**Request for Additional Information No.442 (4295, 5076, 5068, 5067), Revision 1,  
Question 07.01-27**

**U.S. EPR Standard Design Certification**

**Question 07.01-27:**

# U.S. EPR Final Safety Analysis Report Markups

Figure 7.2-3—Manual RT

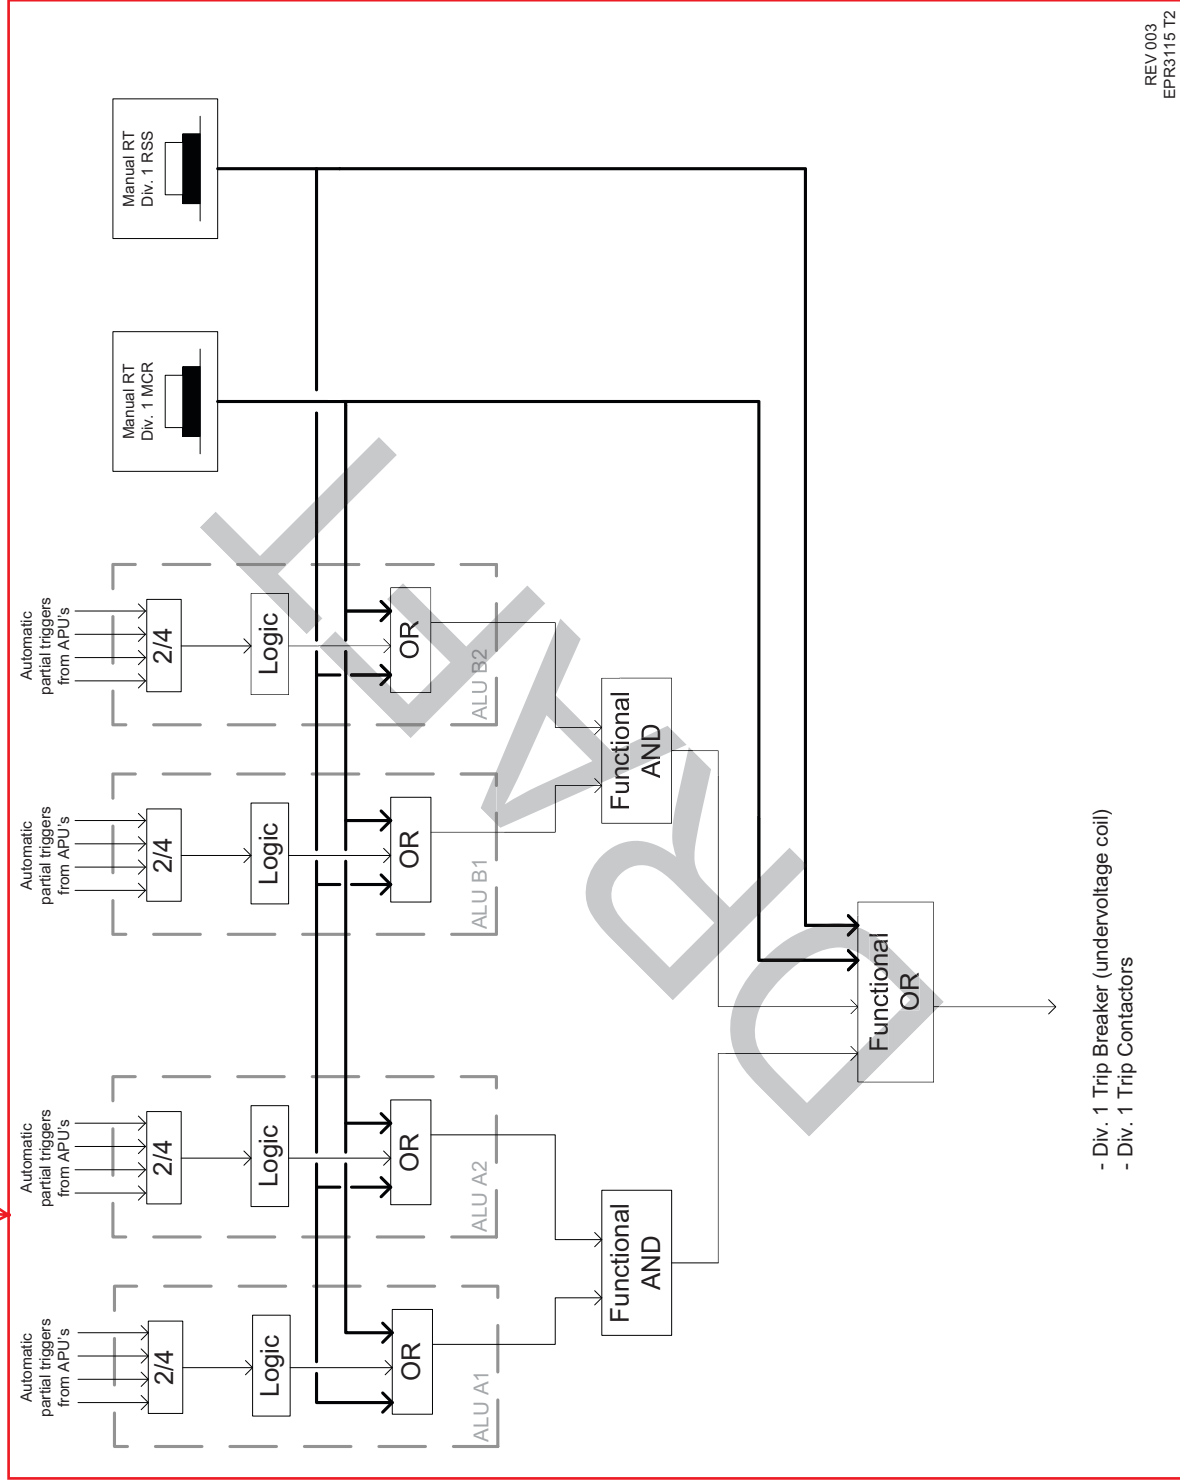
RAI 442, 07.01-27

Figure 7.2-4—Safety Related RT Devices

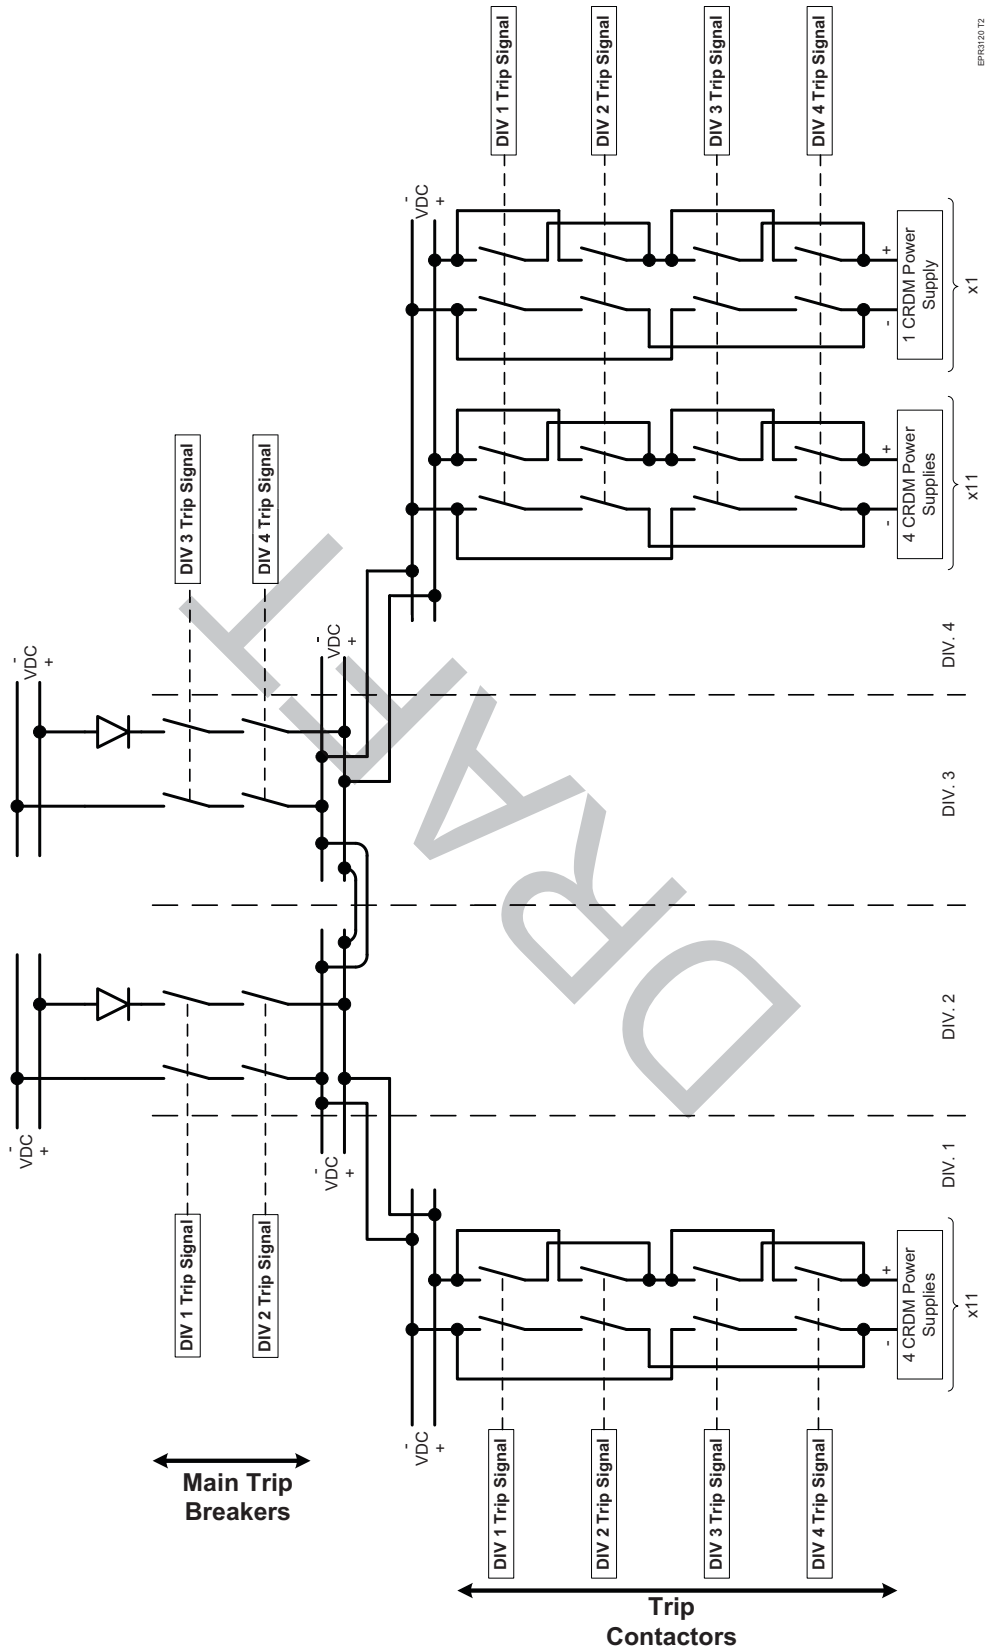
Any one of ~~three~~two diverse sets of RT devices can successfully remove power to the CRDM coils. The sets are the RT breakers, ~~and~~ the RT contactors, ~~and the transistors of the CRDM operating coils~~. When an RT order is generated, the PS acts on ~~all~~ ~~three~~both sets of RT devices as described:

Figure 7.2-24—RT Signal Generation

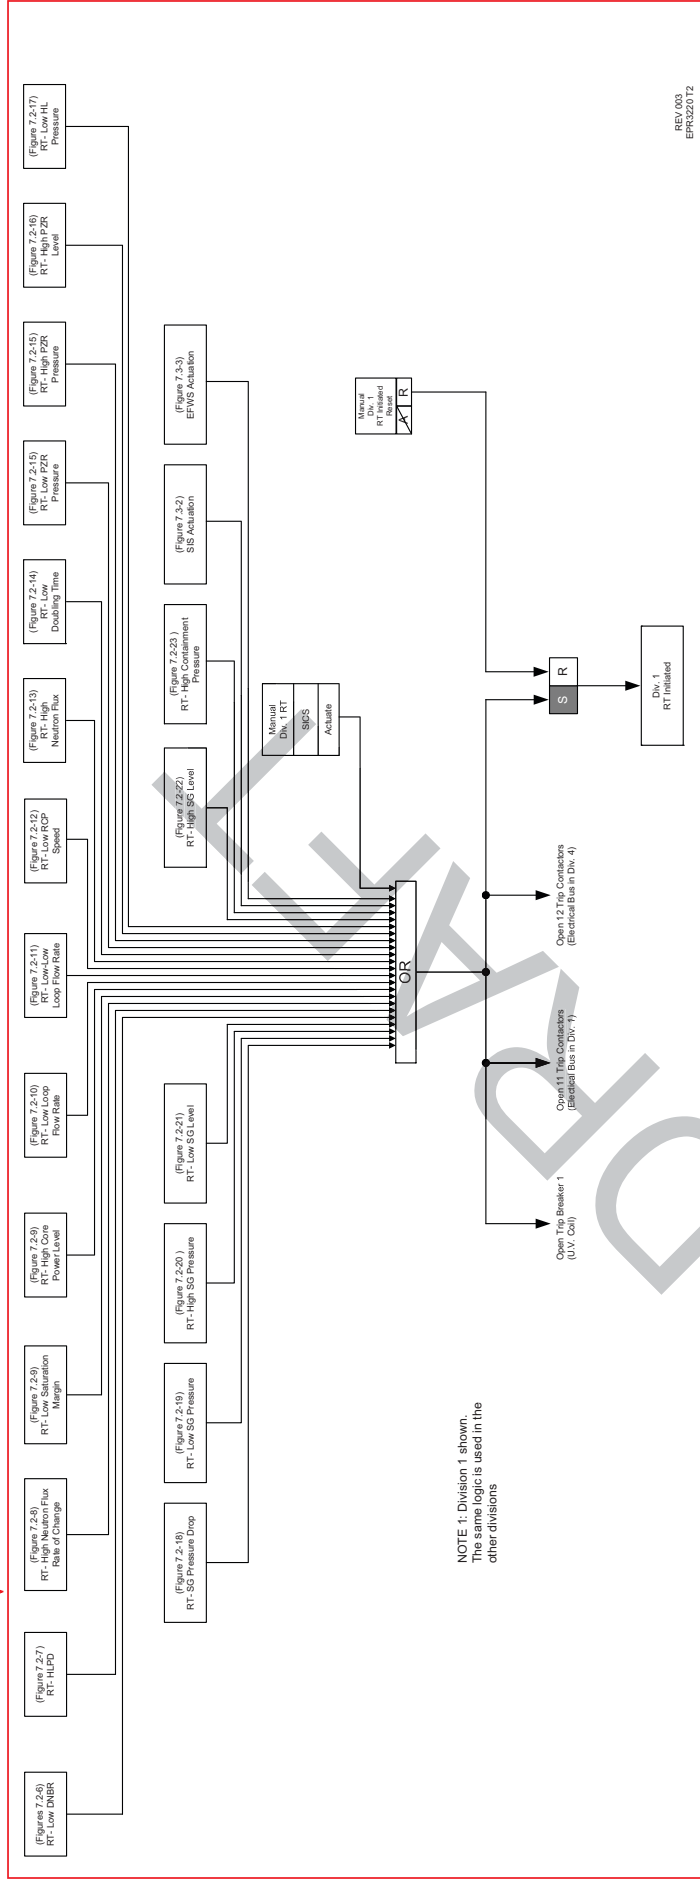
RAI 442, 07.01-27
